Proposed Turkey Point Units 6 and 7
Docket Nos. 52-040 and 52-041
FPL Response to NRC RAI No. 02.05.01-21 (eRAI 6024)
L-2013-236 Attachment 17 Enclosure A Page 1 of 7

SSHAC Level 2 Questionnaire in Support of Cuba Hazard Sensitivity Calculations

NRC RAI Letter No. PTN-RAI-LTR-041

Figure 4 Fault Map of Cuba including Postulated Offshore Las Villas and Sierra de Jatibonica Faults from Reference 2

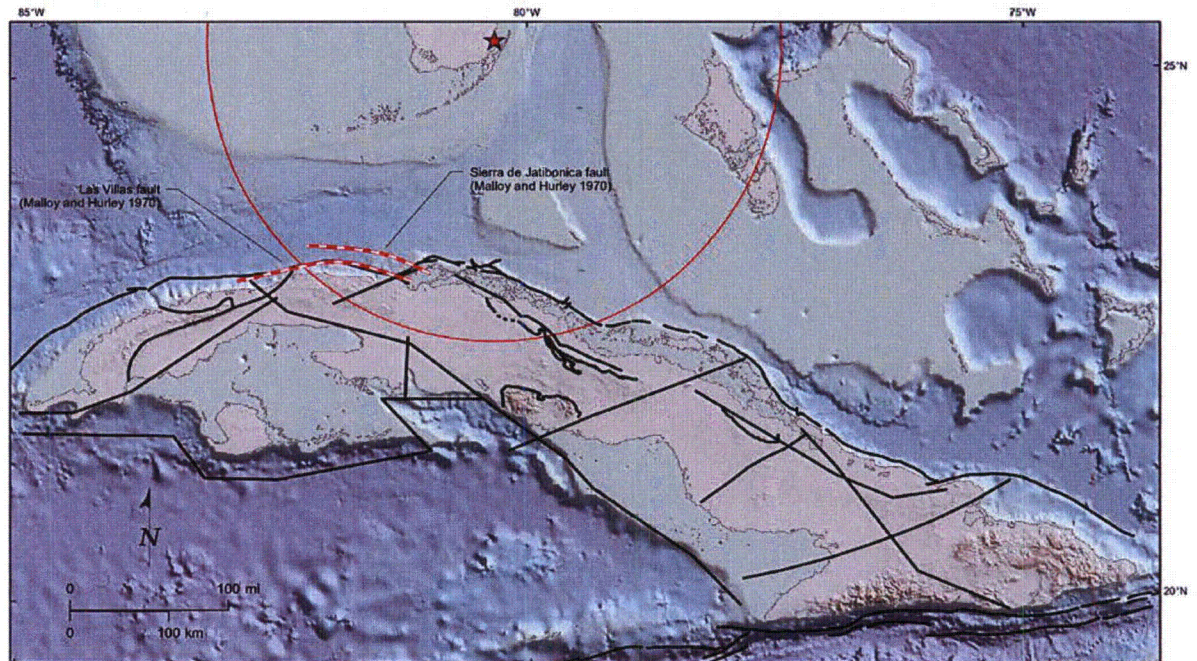
- a) Provide more detail from the Cotilla-Rodríguez et al. (2007) paper regarding the young eroded scarps of the Las Villas fault and specifically address Cotilla's conclusion that the fault is Pliocene-Quaternary in age.
- b) In the context of the chronology of geomorphic surfaces on Cuba, clarify the distinction between erosional processes that may have recently created "young" fault-line scarps along the Las Villas fault and Quaternary tectonic fault scarps.
- c) Discuss bathymetric evidence for the offshore location and recency of faulting along the Las Villas fault.
- d) Address the alignment of epicenters shown on Figure 2.5.1-267 along the Las Villas fault with respect to its tectonic activity. Please plot the uncertainties in event locations and include this information in the discussion.

Figure 4 is a map of faults in Cuba compiled for this project from various sources. This map shows Pardo's (FSAR Subsection 2.5.1, Reference 439) depiction of the Las Villas fault and Case and Holcombe's (FSAR Subsection 2.5.1, Reference 480) depiction of the Nortecubana fault as black lines. Additionally, this map shows Malloy and Hurley's (Reference 2) depictions of the postulated offshore Las Villas and Sierra de Jatibonico faults as red and white lines. As shown on Figure 4, Malloy and Hurley's (Reference 2) offshore Las Villas fault is roughly coincident with Case and Holcombe's (FSAR Subsection 2.5.1, Reference 480) Nortecubana fault between roughly Matanzas Bay and Havana. For this reason, it is assumed that Malloy and Hurley's (Reference 2) offshore Las Villas fault is a portion of what Case and Holcombe (FSAR Subsection 2.5.1, Reference 480) later mapped as the Nortecubana fault and that Malloy and Hurley's (Reference 2) offshore Las Villas fault is not the same structure as the Las Villas fault mapped by Pardo (FSAR Subsection 2.5.1, Reference 439), Cotilla-Rodriguez et al. (FSAR Subsection 2.5.1, Reference 494), Perez-Othon and Yarmoliuk (FSAR Subsection 2.5.1, Reference 848), Pushcharovskiy (FSAR Subsection 2.5.1, Reference 847), and others. As such, Reference 2 observations of possible bathymetric expression of the offshore Las Villas fault are assumed to be irrelevant for assessing the recency of movement on the mostly onshore Las Villas fault as defined by Pardo (FSAR Subsection 2.5.1, Reference 439) and others, but may be relevant for the Nortecubana fault.

Figure 1 Fault Map of Western Cuba Showing Earthquakes from the Phase 2 Earthquake Catalog

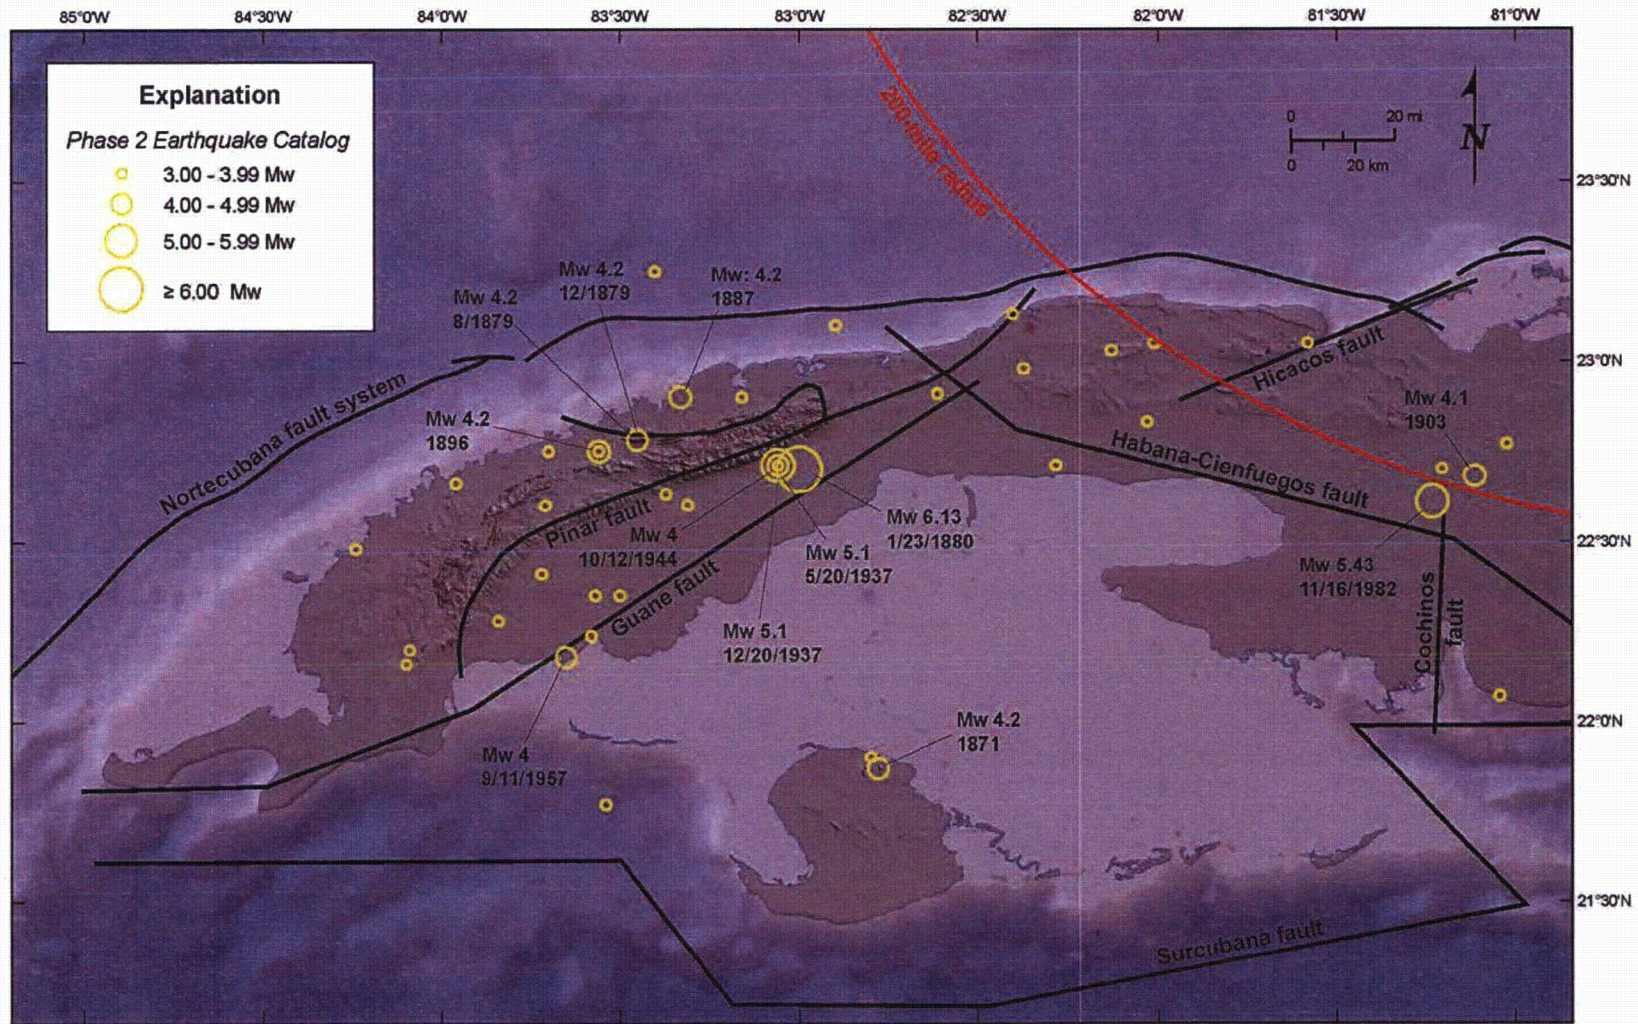
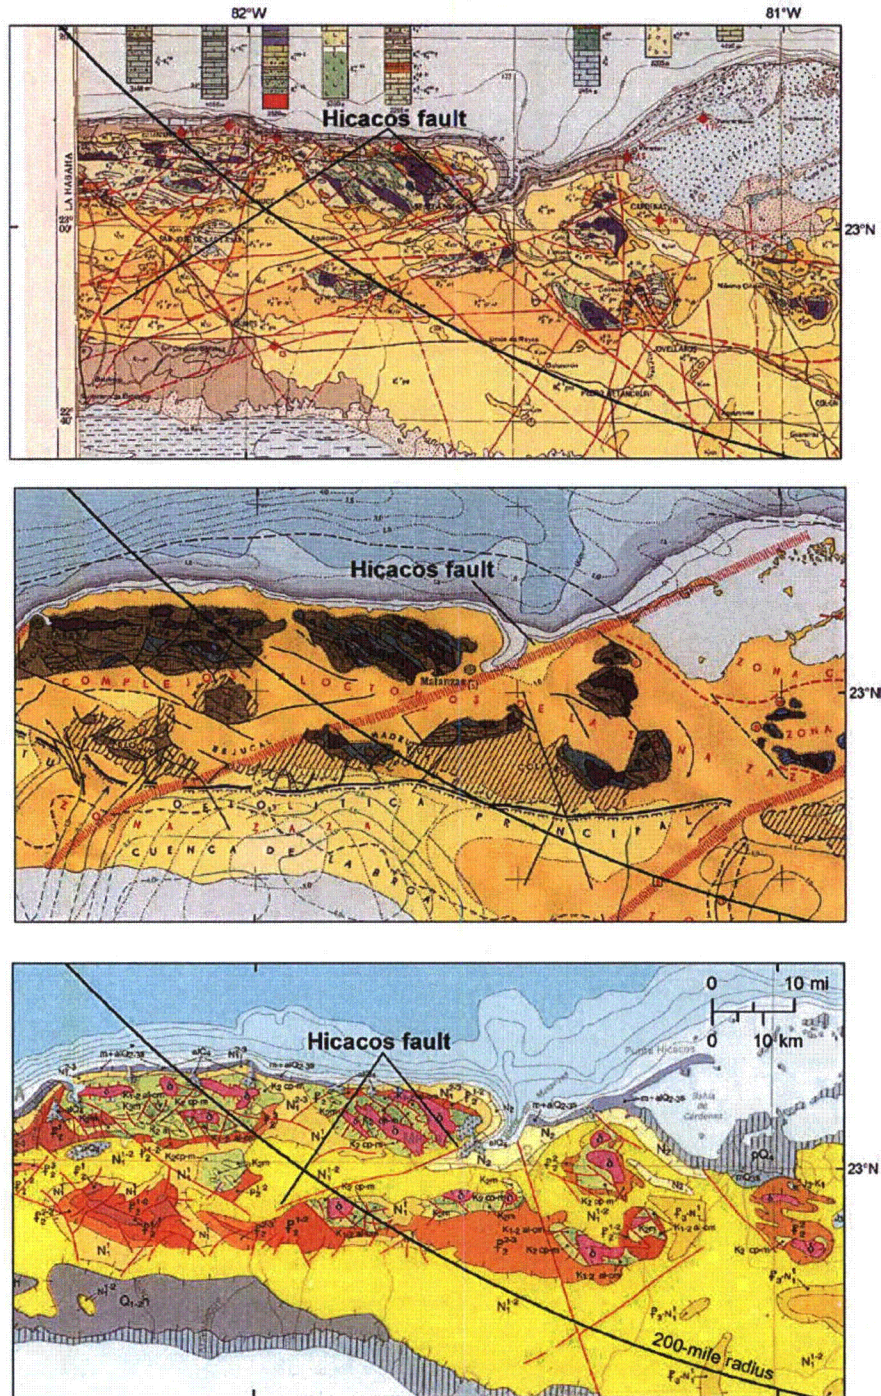
FSAR Figure 2.5.1-251, "Lithostratigraphic Map of Cuba", depicts the Matanzas fault zone within the site region; however, the staff notes that the Matanzas fault zone is not discussed in the FSAR.

The terms Matanzas fault and Hicacos fault refer to the same geologic feature. Most newer publications use the term Hicacos fault, and the FSAR follows this convention. The Hicacos fault is discussed in FSAR Subsection 2.5.1.1.1.3.2.4 and is shown in FSAR Figure 2.5.1-247. FSAR Figure 2.5.1-251 is a reproduction of Stanek et al.'s (2009) Figure 2 (FSAR Subsection 2.5.1, Reference 769), which labels this fault as Matanzas fault. The text of FSAR Subsection 2.5.1.1.1.3.2.4 and FSAR Figure 2.5.1-251 will be modified to indicate that Matanzas fault and Hicacos fault are two names for the same geologic feature. Figures 1 and 2 provide larger-scale maps of the Hicacos fault trace.

Case and Holcombe’s (1980) (FSAR Subsection 2.5.1, Reference 480) 1:2,500,000 scale map of the Caribbean region shows segments of the Hicacos fault cutting upper Tertiary rocks. Perez-Othon and Yarmoliuk’s (1985) (FSAR Subsection 2.5.1, Reference 848) 1:500,000 scale geologic map of Cuba shows an unnamed fault in the vicinity of the Hicacos fault that extends from Matanzas for approximately 50 miles (80 kilometers) to the southwest (upper panel of Figure 2). Because they do not label faults by name, it is not clear whether the Hicacos fault is depicted on Perez-Othon and Yarmoliuk’s (1985) (FSAR Subsection 2.5.1, Reference 848) inset map of fault ages in Cuba. However, they indicate a Mesozoic age for an unnamed fault in the vicinity of the northeastern-most portion of the Hicacos fault. Pushcharovskiy et al.’s (1988) (FSAR Subsection 2.5.1, Reference 846) 1:250,000 scale geologic map of Cuba shows an unnamed fault cutting lower Miocene rocks in the vicinity of the central Hicacos fault, but their mapping does not extend this fault as far northeast as the north coast of Cuba. However, the locally northeast-trending shoreline and a narrow peninsula near Matanzas are notably linear and on-trend with the fault, likely influencing where the fault is mapped in other representations. Pushcharovskiy’s (1989) (FSAR Subsection 2.5.1, Reference 847) 1:500,000 scale tectonic map of Cuba shows the northeastern extent of the Hicacos fault similar to the depiction shown in Figure 1 that terminates to the southwest at Cuba’s southern coast (middle panel of Figure 2).
